<b>Title - Sujet</b> MCCP EIFW	
<b>Solicitation No. - N° de l'invitation</b> 21120-159558/A	<b>Amendment No. - N° modif.</b> 004
<b>Client Reference No. - N° de référence du client</b> 21120-159558	<b>Date</b> 2015-06-15
<b>GETS Reference No. - N° de référence de SEAG</b> PW-\$\$HN-461-67099	
<b>File No. - N° de dossier</b> hn461.21120-159558	<b>CCC No./N° CCC - FMS No./N° VME</b>
<b>Solicitation Closes - L'invitation prend fin</b> <b>at - à 02:00 PM</b> <b>on - le 2015-07-16</b>	<b>Time Zone</b> <b>Fuseau horaire</b> Eastern Daylight Saving Time EDT
<b>F.O.B. - F.A.B.</b> <b>Plant-Usine:</b> <input type="checkbox"/> <b>Destination:</b> <input type="checkbox"/> <b>Other-Autre:</b> <input type="checkbox"/>	
<b>Address Enquiries to: - Adresser toutes questions à:</b> Hallman, Patti	<b>Buyer Id - Id de l'acheteur</b> hn461
<b>Telephone No. - N° de téléphone</b> (819) 956-7390 ( )	<b>FAX No. - N° de FAX</b> ( ) -

*Amendment 004 is issued to provide responses to additional questions received and to provide the Additional Design Requirements for the MCCP Console.*

**DESIGN REQUIREMENTS  
FOR THE  
MAIN CONTROL AND COMMUNICATIONS POST (MCCP) CONSOLE  
FOR USE IN FEDERAL CORRECTIONAL INS

Figure 1 - Preferred Touch Screen User Interface Layout

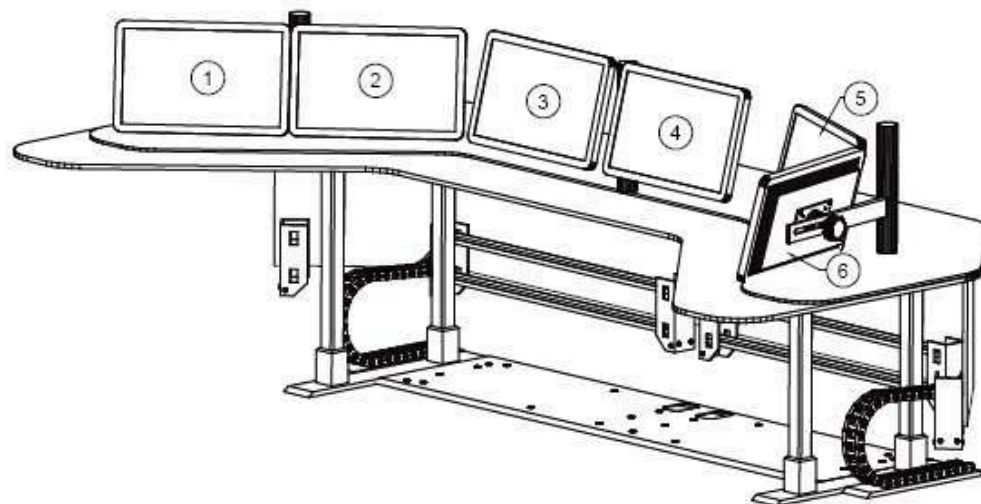
- .1 The console must provide for six (6), 22" side-by side touch screen user interface monitors that are positioned in an open "U" configuration (2 left, 2 centre, 2 right) to allow the Operator to reach the complete display area of all monitors..

- .2 The preferred arrangement for the monitors installed on the console desktop will be:

1.	IMS Workstation User Interface (as required)
2.	Motorola Radio Operator Touch Screen
3.	Perimeter Security (PIDS) Operator Touch Screen
4.	Interior System (FAAS) Operator Touch Screen
5.	Video Management System Operator Touch Screen
6.	Aggregator Operator Touch Screen

**Figure 2 – Layout of Touch Screen User interfaces and Video Monitors**

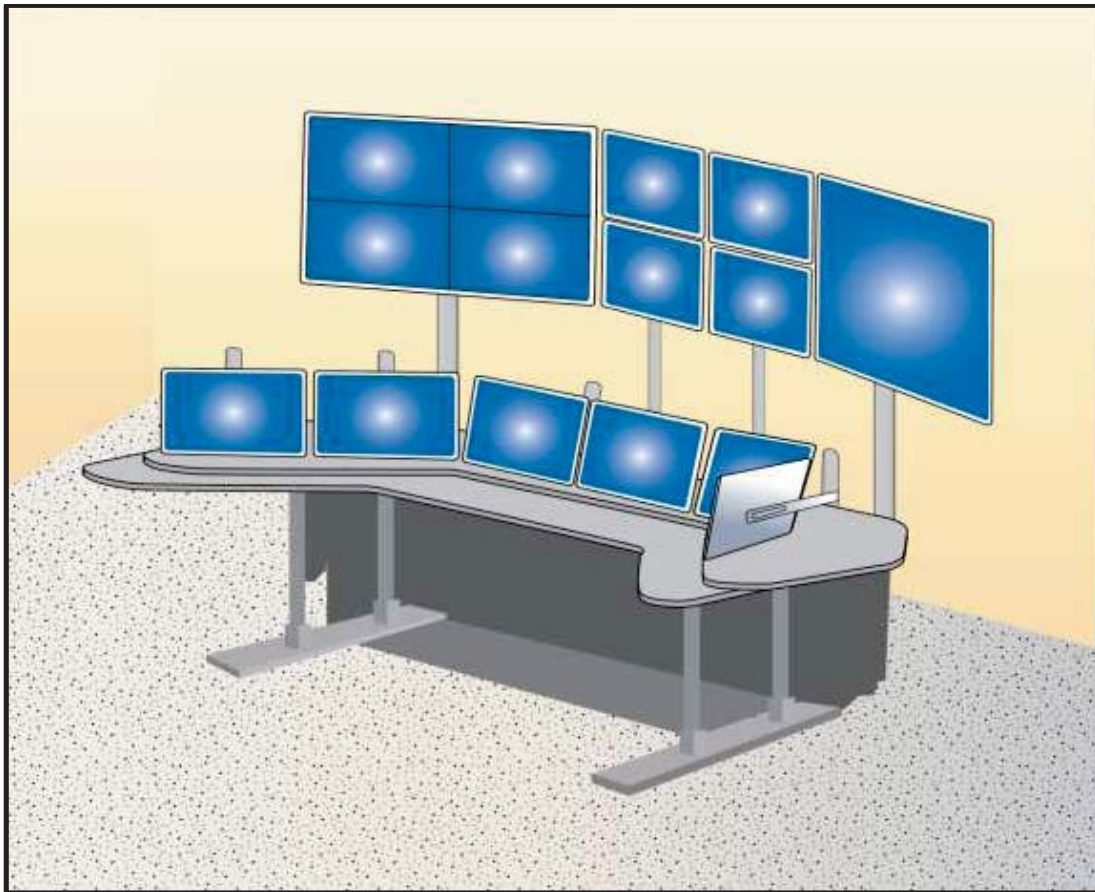
- .3 The mounts for the monitors must be compliant with the VESA FDMI standard. The monitors must be positioned between 5 cm and 10 cm above the desk surface and each monitor must be independently manually adjustable anywhere from vertical to at least 20 degrees back from vertical without interfering with adjacent monitors.

- .4 The console must be equipped with four (4), 22" side by side video monitors that are positioned immediately above and centred over the PIDS and FAAS touch screen user interface monitors and two (2) 42" video monitors that are positioned with one monitor on each side of the 22" side by side video monitor array. All six (6) monitors are for display only. For reference purposes, these monitors are numbered from 7 to 12 going left to right and top to bottom. The four (4) 22" video monitors that display the PIDS camera views will be on monitors 8,9 10,11, quad screen camera views displayed on 7 or 12 and a full screen camera view will be displayed on 12 or 7. The final assignment of the video monitors will be determined by the institution's equipment requirements and preferences..

- .5 The mounts for the video monitors must be compliant with the VESA FDMI standard. The mount must allow each monitor to be positioned independently anywhere from vertical to at least 20 degrees forward from vertical. The mount must allow each monitor to be positioned forward or backward to have the bezel adjacent to the bezel of the user interface monitor in any possible user interface monitor position.
